Access Compliance Report

Public Rights-of-Way

(Curb Ramps)

Intersection ID: 49249	Main Street: BOOMERANG_WY	Cross Street: PROSPERITY_VIEW_DR	Location: NW
ADA ID: 615450D2BB22	Ramp Type: BlendTrans1	Initial Pass/Fail: Pass	Overall Compliance: No
		Severity Score: 20

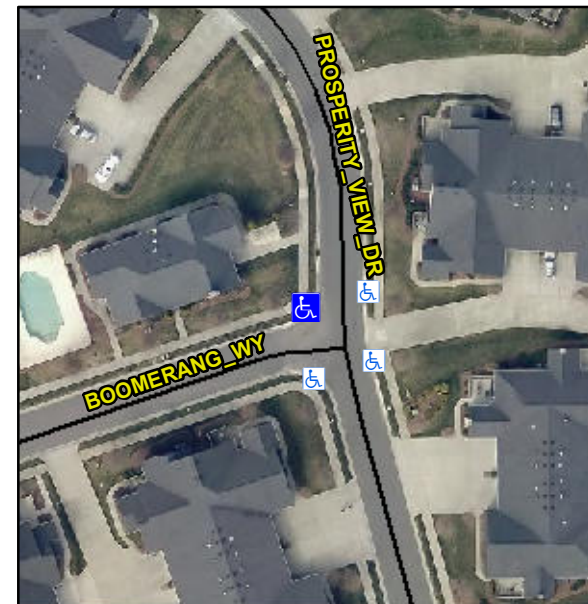
Not Found, R305.2, R302.7, R302.7.2, R304.5.4, R304.5.3

Remove & Replace Curb Ramp With Two New Directional Ramps or Equivalent. Remove & Replace Gutter.
